**STAFF ANALYSIS
OF THE
WHITE ROSE DEVELOPMENT PLAN
AMENDMENT APPLICATION

WEST WHITE ROSE PILOT SCHEME

2010-06-24**

Figure 4.4.2– C-30Z DST Intervals (Source: Husky)

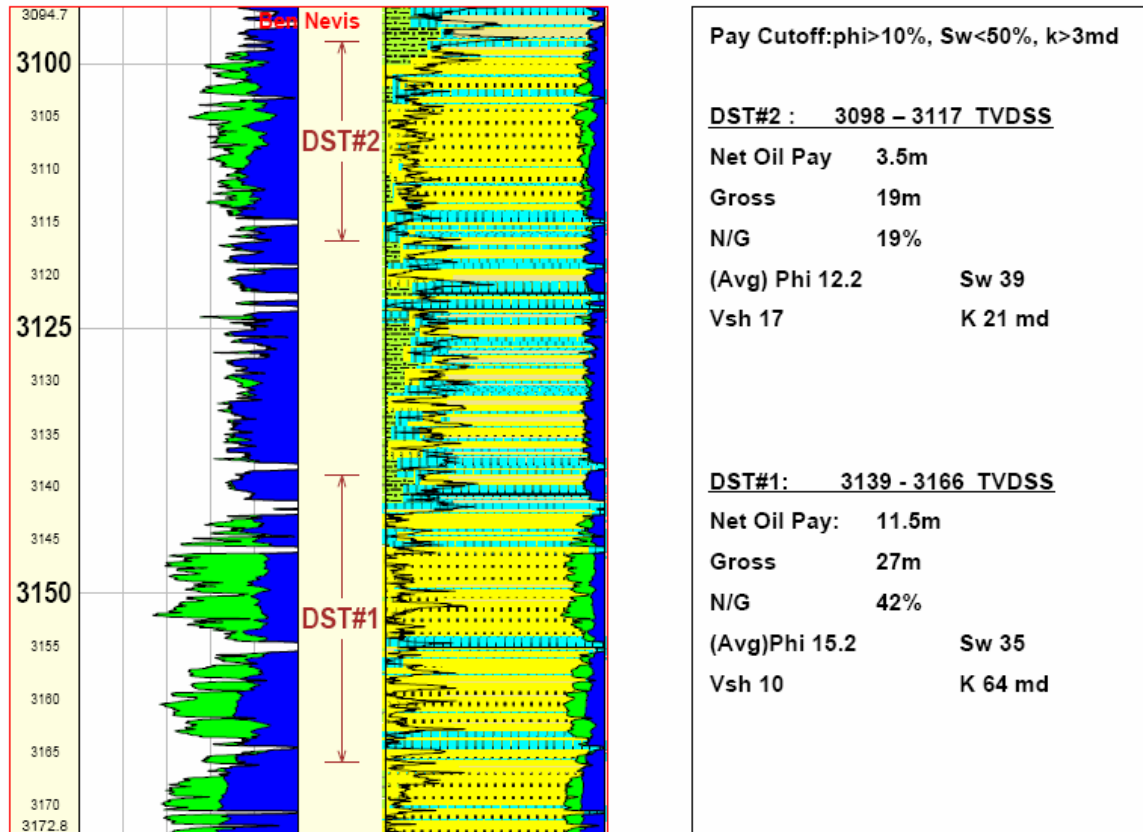
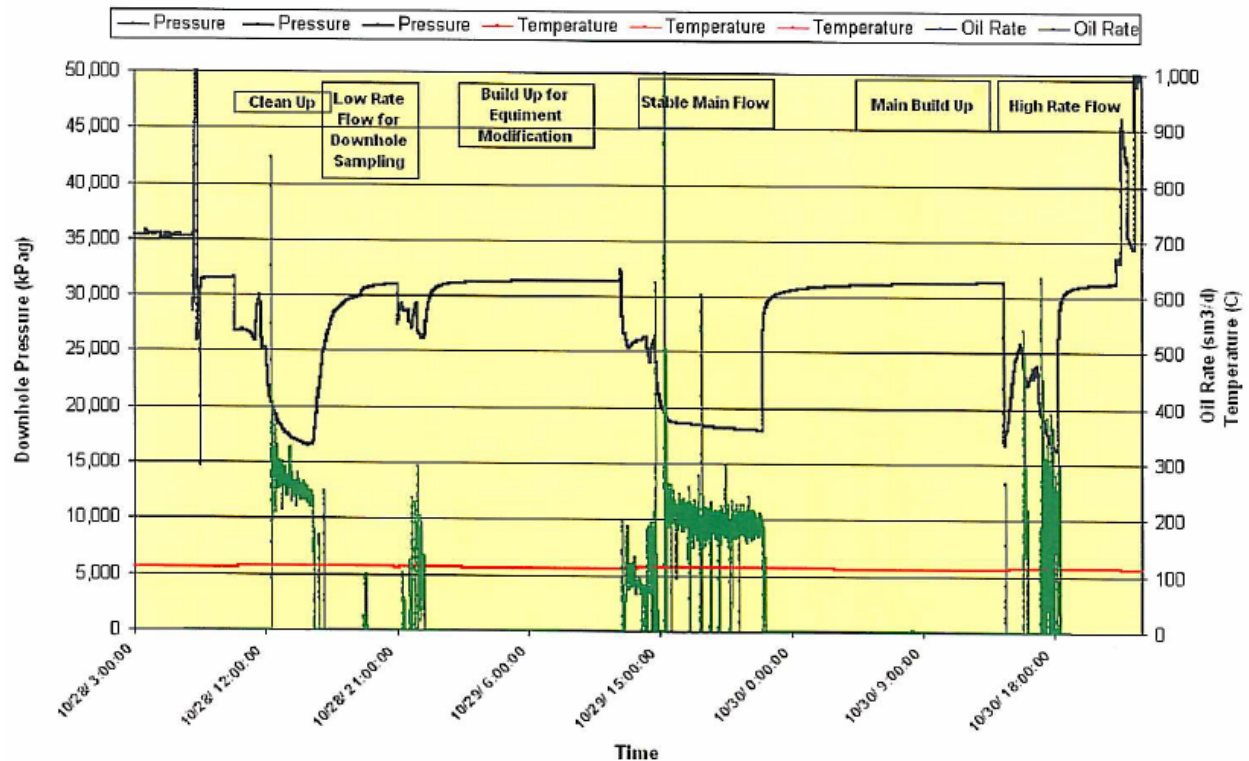
Staff reviewed the DST results and the Proponent’s interpretations of the DST pressure build-ups and found them to be reasonable.

Figure 4.5.1 Preliminary Target area for Pilot project (Source: Husky)

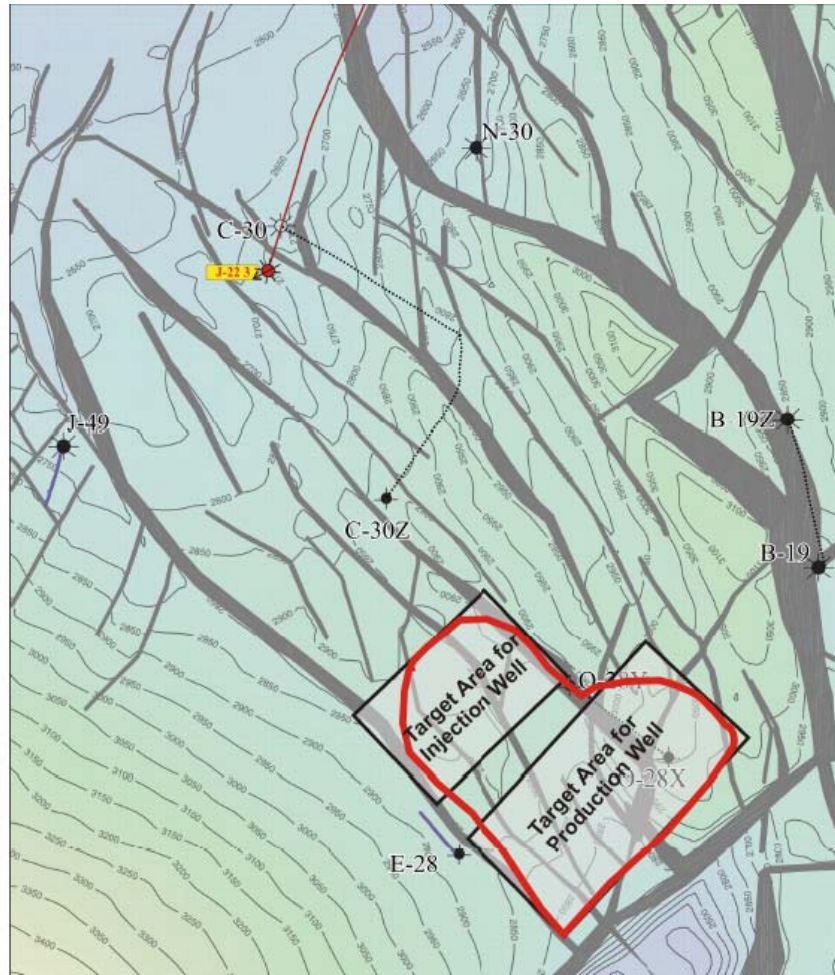
Board staff requested this additional information and were subsequently informed that the producer would be highly deviated and target all Ben Nevis Avalon facies above the OWC (3170m TVDss), while the injector would be slightly deviated and target all facies. Details of the Proponent's well trajectories and proposed locations are indicated in Figure 4.5.2.2.

Board staff also requested additional information pertaining to the selection of the proposed “target area” in relation to the pilot scheme objectives. In particular, Board staff wanted to understand how the pilot would reduce risk and uncertainty in the more distal areas of the West White Rose pool.

The Proponent indicated that the location was selected based on the proximity to the O-28Y well, which will be used for landing out the pilot producer’s heel. This is important in understanding the potential stratigraphic barriers with higher quality sand in this area. The selected location and trajectory also permits intersection with a maximum range of facies sequences. Other pilot scheme locations were reviewed by the Proponent, but the selected region is expected to provide the best opportunity for clear indicative results

Figure 4.5.3 Proposed Timeline and Development schedule for West White Rose Pilot Scheme
(Source: Husky)

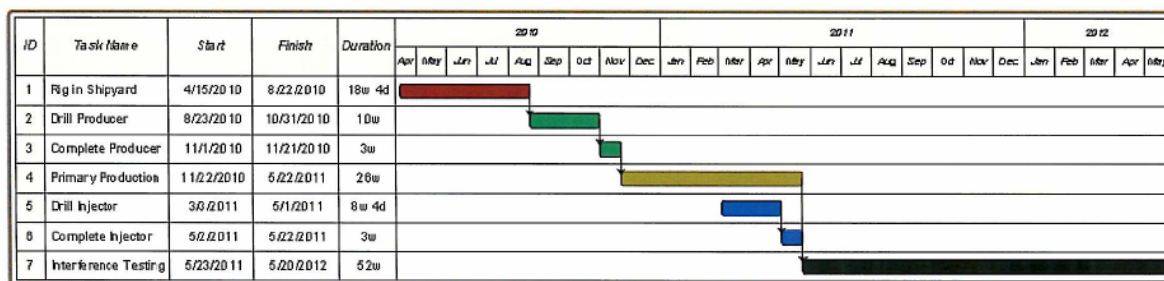
The preliminary schedule for development of West White Rose pilot scheme was provided in the Application. However, it should be noted that this schedule is outdated. The Proponent stated the timeline provided is preliminary and that the order, sequence and durations are subject to change. At the time of staff analysis, the pilot producer for the West White Rose is scheduled to be completed in April 2011.

Staff concur with the overall proposed preliminary schedule of the pilot scheme. The order, sequence and durations proposed by the Proponent seem reasonable and allow enough time to obtain testing information. Staff realize that due to issues such as rig availability, weather etc., the proposed dates and durations may change. **However if there is significant alteration from the pilot scheme as outlined in the Application, the Proponent will require approval from the Board.**

Figure 4.7.7: West White Rose Pilot Region Reservoir Pressure (Source: C-NLOPB)

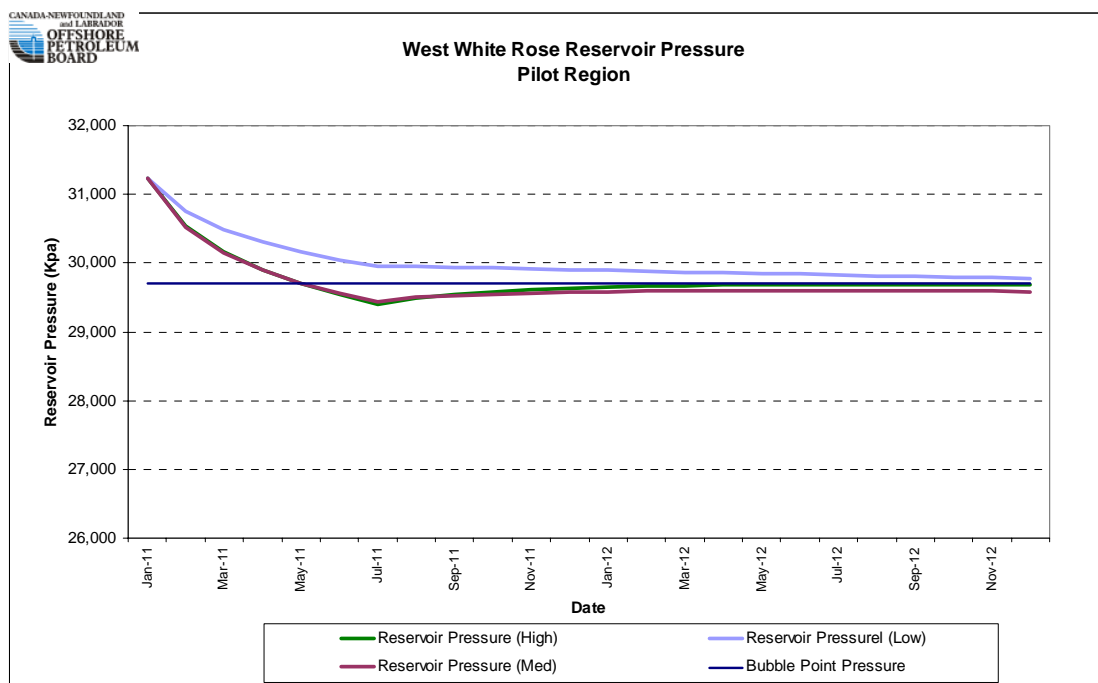
The field pressure profile relative to bubble point is presented for each simulation case for the two-year evaluation period (Figure 4.7.4.1). The bubble point used for the West White Rose Pilot Region (29,710 KPa) was taken from the O-28Y Differential Liberation Oil PVT Summary. As depicted in Figure 4.7.4.1, the regional pressure drops in all cases during the initial six-month primary production period. Following this period, pressure slowly increases as the injector comes on line. In the case of the medium and high cases, regional pressure drops below bubble point, but in the high case, regional pressure gets back to bubble point following nine months of injection. In the medium case, regional pressure stabilizes just below bubble point. In the low case, regional pressure does not drop below bubble point during the initial six month primary production period. However, pressure continues to drop once injection has been established, suggesting very poor communication between the producer and the injector.

The effects of producing the pilot production well on primary for a six month period raised concerns for Board staff as it is normally preferable for pressure to be maintained

above bubble point. However, in the context of a pilot project, the pressure management scheme outlined by the Proponent is reasonable given the need to understand issues like injectivity and communication between the producer and injector. In addition, reservoir simulation cases were run by the Proponent to evaluate the effects of the primary production period and it was found to have negligible long term effects on ultimate oil recovery from the pilot producer, as illustrated in Figure 4.7.4.2.

Figure 4.8.1 – Impact of West White Rose Pilot Scheme (Source: Husky)

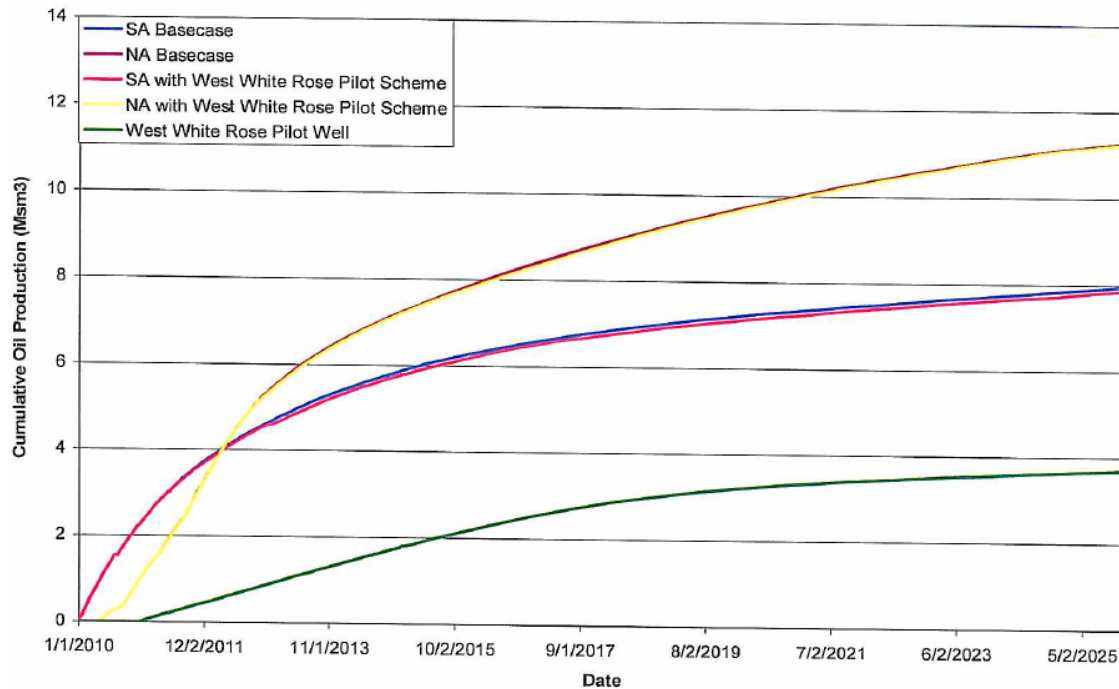
Staff had concerns with potential effects of implementing a pilot scheme in the West White Rose Pool on South Avalon and North Amethyst production. The pilot well scheme will utilize two slots from the Central Glory hole. The Proponent indicated in the response to the request for additional information that the two 10" production lines from the Central Glory Hole have adequate hydraulic capacity to ensure the predicted well deliverability can be achieved without impacting the overall recoverable reserves from South Avalon and North Amethyst over the life of the field. This is illustrated in Figure 4.8.1 which was generated by the Proponent using their Integrated Production Model (IPM). Overall, no impact on the manifold or development in South Avalon and North Amethyst is anticipated.
